Mobile Intel[®] Pentium[®] II Processor Specification Update

Release Date: October 2001

Order Number: 243887-034

The Mobile Pentium[®] II processor may contain design defects or errors known as errata which may cause the product to deviate from published specifications. Current characterized errata are documented in this Specification Update.

New Mobile Pentium® II Processor in Mini-Cartridge Package Label with Supplier Matrix Mark Removed

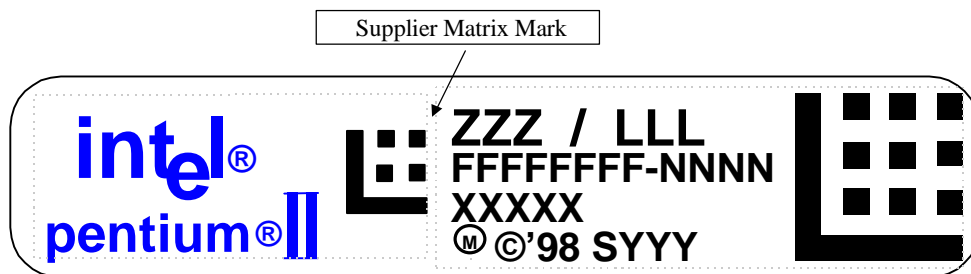
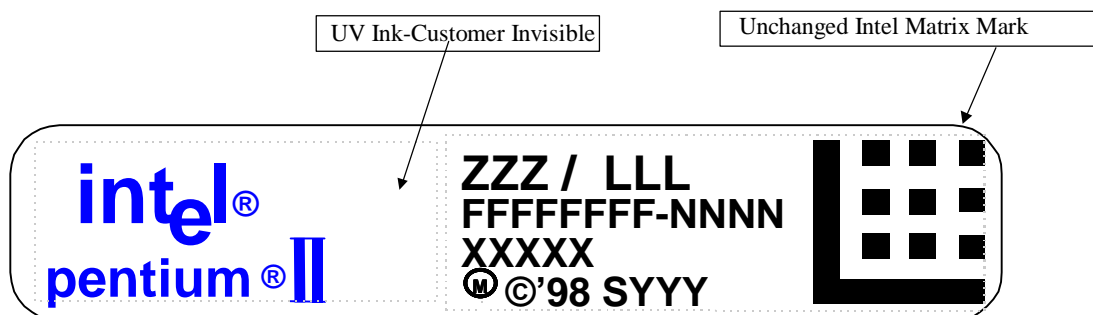
Old Mobile Pentium® II Processor in Mini-Cartridge Package Label with Supplier Matrix Mark

Figure 2. Workaround Flowchart: SMBALERT#-Driven System

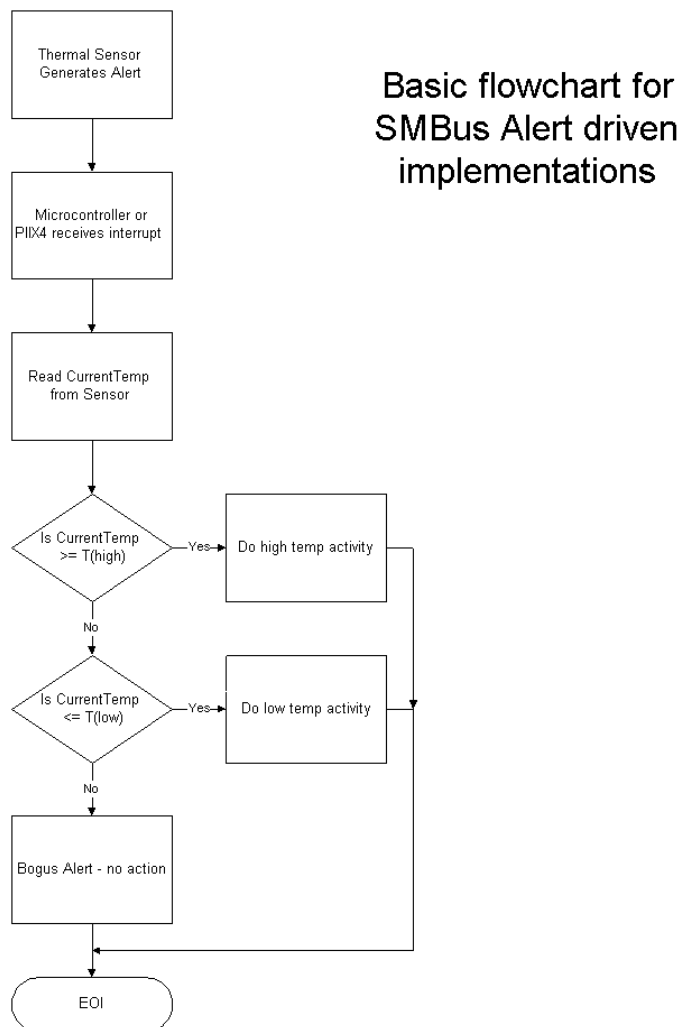
Under the conditions described below, the thermal sensor incorrectly generates the SMBALERT# interrupt. All of the following conditions must be met to trigger a false interrupt:

1. Before servicing an interrupt from the thermal sensor, read and compare the processor thermal reading with the threshold limits (T_{HIGH} or T_{LOW}). Figures 2 and 3 provide basic flowcharts for the implementation of this workaround in an interrupt driven system.
2. If the firmware implemented polls the Status Register only, then before taking any action, re-read the temperature register and do a comparison with the alarm threshold limits (T_{HIGH} or T_{LOW}) to determine if the value is actually still within the temperature window.

3. Use a temperature polling scheme to monitor the processor temperature.

Figure 1. TAP Gageable Thread Clarification

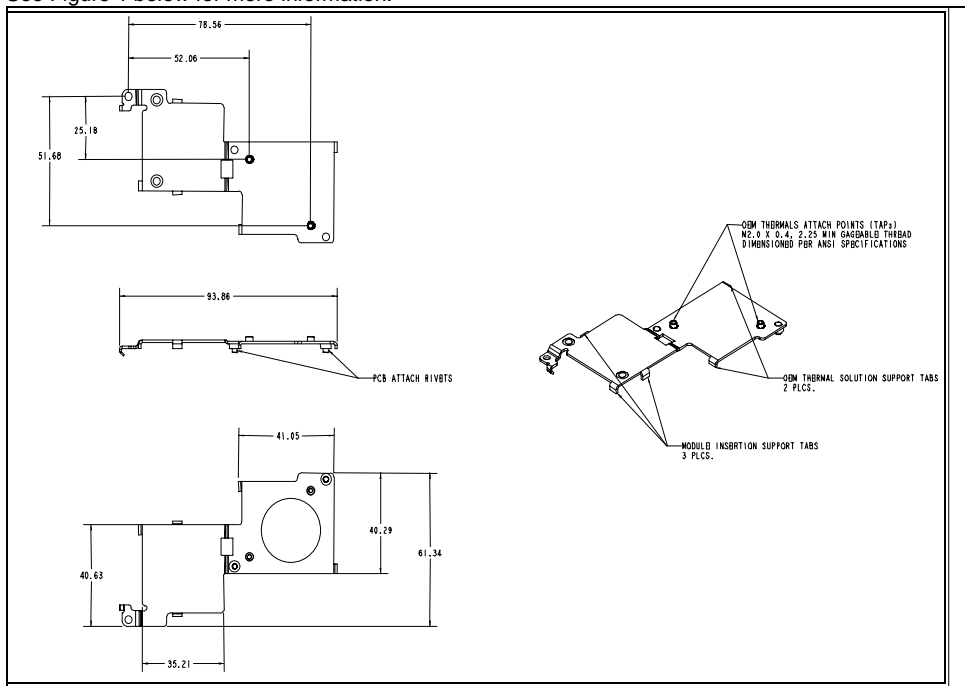
In the *Intel® Pentium® II Processor Mobile Module : Mobile Module Connector 1 (MMC-1)* and the *Intel® Pentium® II Processor Mobile Module : Mobile Module Connector 2 (MMC-2)* datasheets (Order Numbers 243667 and 243668, respectively), the thermal attach point (TAP) gageable thread specification was not clearly identified in Figure 14, of Section 5.2. The following is the TAP clarification:

OEM Thermal Attach Points (TAPs) M2.0 x 0.4, 2.25 min gageable thread dimensioned per ANSI specification.

See Figure 1 below for more information.
